UNITED STATES PATENT AND TRADEMARK OFFICE

APPLICATION NO.	FILING DATE	FIRST NAMED INVENTOR	ATTORNEY DOCKET NO.	CONFIRMATION NO.
10/070,501	03/07/2002	Vladimir Kliatzkin	P-2684-US	7024

Office Action Summary

DETAILED ACTION

Figures 18 and 20 below illustrate battery embodiments

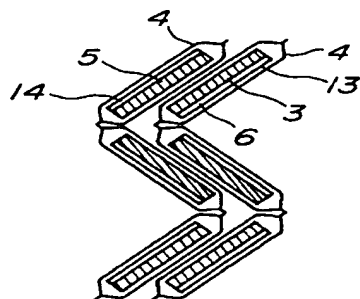
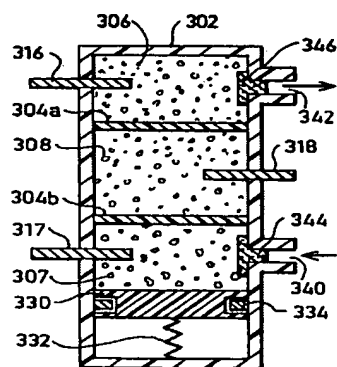
13. Claims 1-3 are rejected under 35 U.S.C. 102(b) as being anticipated by Honda et al 5580676.

Honda et al disclose a rectangular battery including a plurality of cathode plates and anode plates alternately superposed via a separator to face each other. The cathode plates and the anode plates are consecutively packed with the separator and being folded at a separator fusing portion between the plates (ABSTRACT). It is disclosed that the anode plate is formed by a copper foil having both or one side thereof coated with a mixed anode agent; the separator is composed of a polymeric material and the rectangular battery has at least the cathode plates or the anode plates respectively packed with the separator, intrusion of the powder of the cathode plate and the anode plate into each other is prevented (COL 2, lines 25-38). It is disclosed that the layered product formed by the electrode plates and the separator is inserted into a rectangular battery casing and then a liquid electrolyte is filled therein (COL 1, lines 15-20). It is disclosed the electrode are enveloped by or packed between the separators and the packed electrode plates being folded at the separator fusing portion (COL 1, lines 60-67).

Thus, the claims are anticipated.

FIG. 5

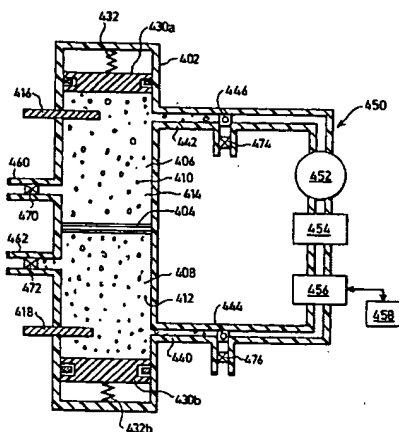
14. Claims 1-3 and 11-12 are rejected under 35 U.S.C. 102(b) as being anticipated by Erez et al 5480742.

Erez et al teach an electrochemical cell including compressed-unbonded electrode granules and liquid electrolyte (TITLE); including a housing containing a cathode electrode, an anode electrode, electrode terminals; characterized in that the electrodes are in the form of unbonded granules located in separate compartments within the housing and separated by a separator; the granule filling their respective compartments and being subjected to compressive forces to produce good electrical contact between their outer surfaces (ABSTRACT).

The above figures depict the electrochemical cell having a housing with two separators thereby dividing the interior of the cell into three compartments; and the terminals could be connected together wherein the two outside compartments serve as the cathode and the middle compartment acts as the anode (COL 4, lines 26-38). Figure 5 shows a similar electrochemical cell wherein the housing comprises an insulating layer polypropylene or rubber (COL 4, line 62 to Col 5, line 7).

Thus, the claims are anticipated.
